2023-08-29

Client: 85.1
Firmware: 85.1

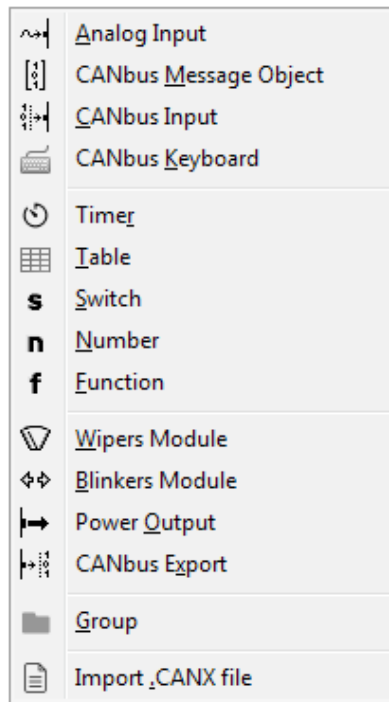
- Evaluation order of elements has been changed to reflect order in the Project Tree. Now the evaluation order is the same as in the ADU.
